Access Compliance Report Public Rights-of-Way (Curb Ramps)

Intersection ID: 24416 Main Street: PARK_RD **Cross Street: JOHNSTON_RD** Location: NW ADA ID: 811539E8E09A Ramp Type: PerpDiag Initial Pass/Fail: Fail **Overall Compliance: No** Severity Score: 13.75

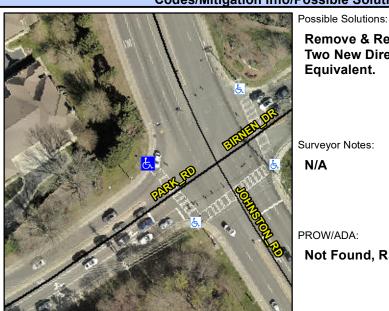
Not Found, R304.2.2, R304.5.3

Field Measurements/Component Compliance					
Compliance Description		Data	Comp	liance Description	Data
N/A	Ramp Length (in)	60.0	No	Ramp Slope (%)	10.6
Yes	Ramp Width (in)	48.0	No	Ramp XSlope (%)	2.8
N/A	Flare Type LT	N/A	N/A	Flare Type RT	N/A
N/A	Flare Slope LT (%)	N/A	N/A	Flare Slope RT (%)	N/A
N/A	Flare Traversable LT?	N/A	N/A	Flare Traversable RT?	N/A
N/A	Landing Length (in)	N/A	N/A	DWS Provided?	N/A
N/A	Landing Width (in)	N/A	N/A	DWS Contrast?	N/A
N/A	Landing Slope (%)	N/A	N/A	DWS Length (in)	N/A
N/A	Landing X Slope (%)	N/A	N/A	DWS Full Width?	N/A
N/A	Landing Curb? (Y/N)	N/A	N/A	DWS Offset (in)	N/A
N/A	Shared Landing?	N/A			
N/A	Gutter Ponding?	N/A	N/A	Gutter Slope (%)	N/A
N/A	Gutter Lip Ht (in)	N/A	N/A	Gutter X Slope (%)	N/A
N/A	Painted X Walk1?	Yes	N/A	Painted X Walk2?	No
	X Walk 1 Direction	To SE		X Walk 2 Direction	To NE
N/A	X Walk 1 Width (in)	108.0	N/A	X Walk 2 Width (in)	N/A
	X Walk 1 Slope (%)	1.2		X Walk 2 Slope (%)	1.4

PARK RD Street 1 Name Stop Condition-Street 2 Signal Street 2 Name **JOHNSTON RD** Stop Condition-Street 1 Signal Remove & Replace Curb Ramp With Two New Directional Ramps or Equivalent.
